Docket No. 72-1008, Certificate of Compliance (CoC) No. 1008

Subject: Submittal of Responses to NRC's 2nd Round RAIs for HI-STAR 100 Amendment
Number 3

**Docket No. 72-1008
Certificate of Compliance No. 1008
HI-STAR 100 Cask Storage System
Amendment No. 3**

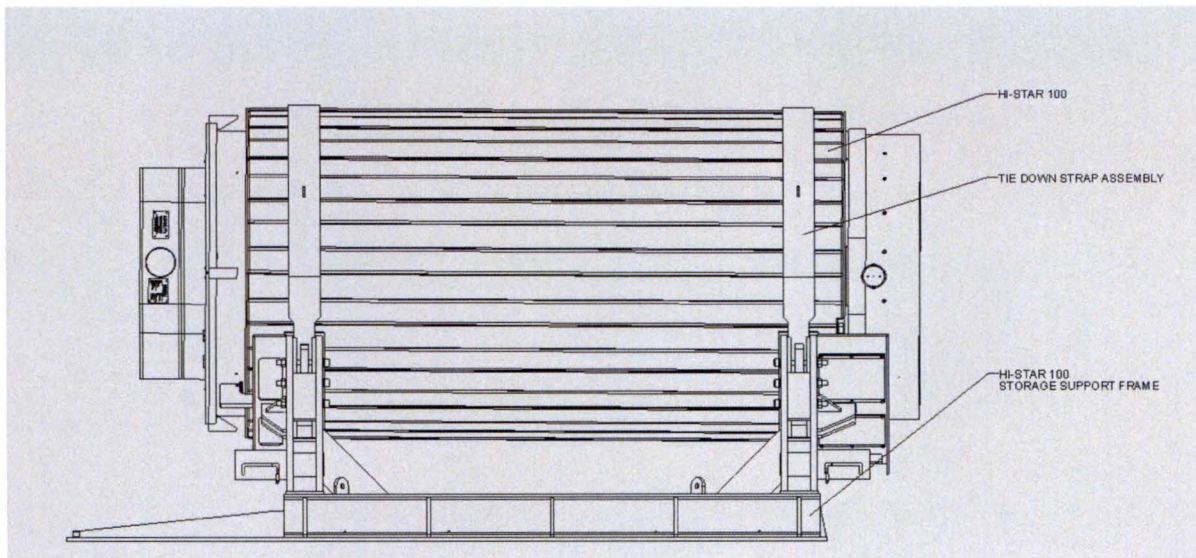
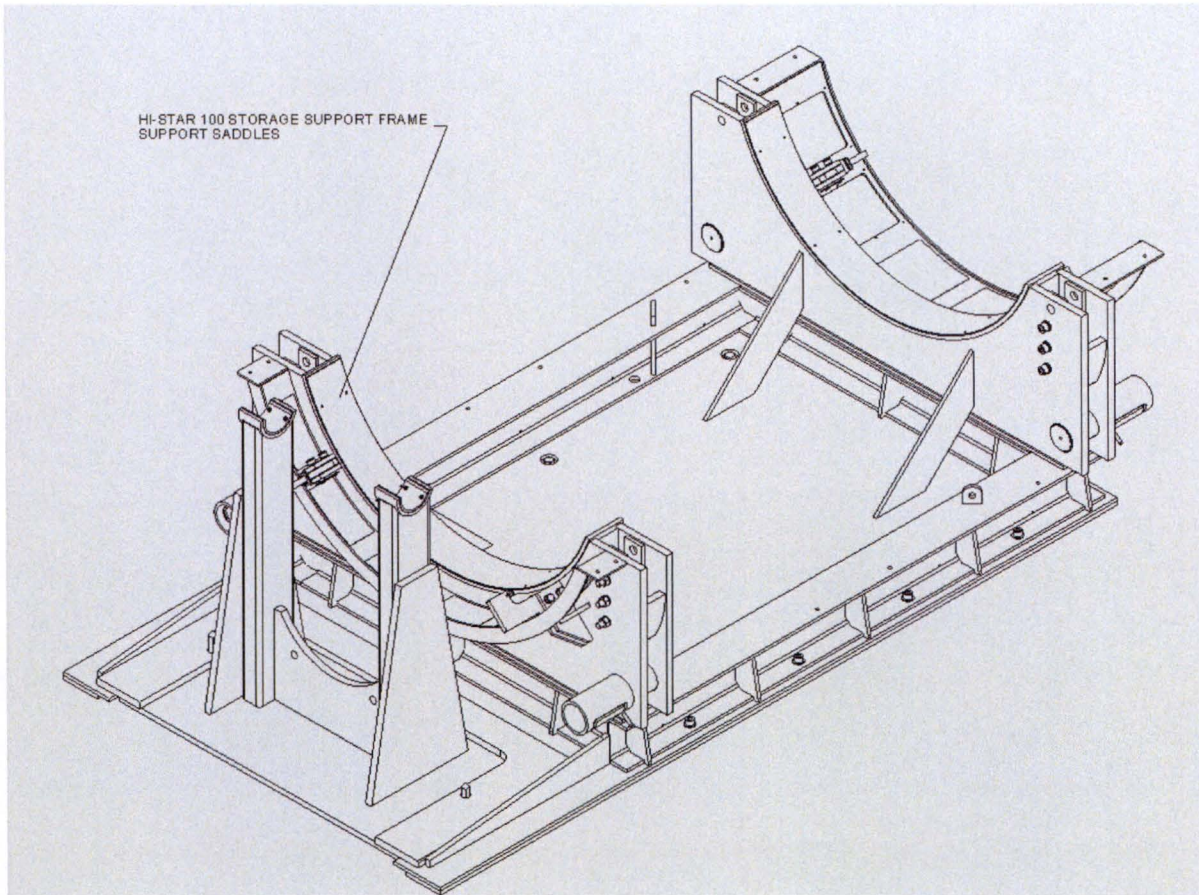
- 4-2 Provide additional discussion, descriptions, more specific incorporation by reference, or thermal analyses, to address how the physical attributes of the horizontal emplacement structure affects the thermal performance characteristics of the HI-STAR 100 Cask Storage System when emplaced in a horizontal orientation, for normal, off-normal, and accident conditions.

The staff needs additional information, either through design drawings, detailed descriptions, incorporation by reference, or thermal analyses, to verify that the boundary conditions accorded by the horizontal emplacement structure do not affect the thermal performance characteristics of the HI-STAR 100 in storage. The applicant should ensure that the most bounding MPC type is addressed. Because the horizontal emplacement of the HI-STAR 100 System has not been previously discussed or analyzed by the applicant, the method by which a HI-STAR 100 cask system would be placed on a storage pad at an ISFSI or interim storage facility is not known. The means of emplacement are an important element in determining off-normal and accident conditions that could occur during the movement of the HI-STAR 100 cask system to its storage configuration. Postulated off-normal and accident conditions (including a fire during the movement evolution, or a seismic event during storage, for example) would be different for a cask being placed in a horizontal vs. a vertical storage configuration. The off-normal and accident conditions that could occur during the emplacement of the HI-STAR 100 cask system in a horizontal storage configuration should be considered and analyzed to demonstrate that the cask maintains its safety functions under these conditions. The emplacement structure, and its effect on the cask system, should also be considered in these analyses. If the applicant chooses to provide additional justification or incorporation by reference to address the staff's request, it should ensure that the information provided is thoroughly discussed and/or properly referenced in its proposed FSAR revision. Alternatively, if the applicant chooses to provide additional thermal analyses to address the staff's request, the applicant should submit any associated input and output files with its response.

Holtec Response: In the horizontal orientation for storage, the HI-STAR 100 is supported by saddle-type supports located near the cask's extremities as shown in the following figures. As can be seen from the figures below, the saddles cover on the order of 40% of the cask circumference. Metal tie-down straps wrap around the remainder of the circumference at the same axial locations to secure the cask to the saddles. A tilting plate bolted to the cask base surface assists in rotating the cask from vertical to horizontal, and is left in place afterwards to provide additional gamma and neutron shielding.

The relevant dimensions of the saddle supports and tie-down straps are listed in the following table.

These saddle dimensions shall be used whenever the HI-STAR 100 cask is held horizontally. The above figures and horizontal emplacement structure dimensions will be added to the FSAR.

As can be inferred from the above figure, the configuration of the HI-STAR 100 cask in horizontal storage emulates its configuration in transport, with the notable difference that there is no impact limiters to reduce the rejection of heat from the cask's ends. This deduction is borne out by the Fluent analysis summarized below.

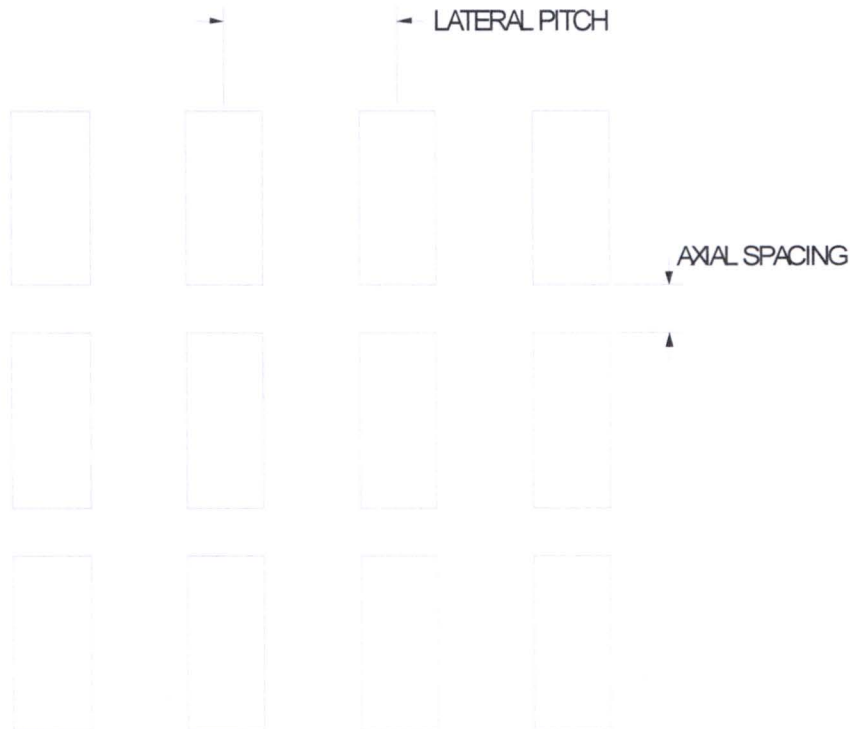
- 4-4** Provide discussion and results of the thermal analysis in Section 4.4.1.1.7 of the FSAR that addresses the thermal interaction among casks in an array that ensures the cask array pitch or center-to-center spacing is bounding for all cask contents/MPCs, considers the most bounding combination of vertical and/or horizontal cask orientation, and provides justification for the most bounding combination of vertical and/or horizontal cask orientation.

The thermal interaction among casks in an array for the most bounding combination of vertical and/or horizontal cask orientation has not been described in Section 4.4.1.1.7, "Heat Rejection from Overpack Exterior Surfaces," of the HI-STAR 100 Cask Storage System FSAR. It is not clear if both horizontally and vertically oriented casks will be mixed, if the calculated cask array pitch (12 feet) is bounding for any combination of cask orientations, or if the minimum spacing is bounding for any type of canister models (e.g. MPC-24, MPC-32, and MPC-68).

Holtec Response: The required minimum cask-to-cask pitch of 12 feet in both orthogonal directions, specified in Section 1.4 of the proposed FSAR, is applicable to arrays of vertically-oriented casks only. For arrays of horizontally-oriented casks, a minimum lateral cask-to-cask pitch of 18 feet and a minimum axial cask-to-cask clearance of 5 feet is proposed (as shown in the following sketch).

Vertically-oriented and horizontally-oriented casks will not be combined within an array, and a separation of at least 18 feet will be maintained between adjacent arrays.
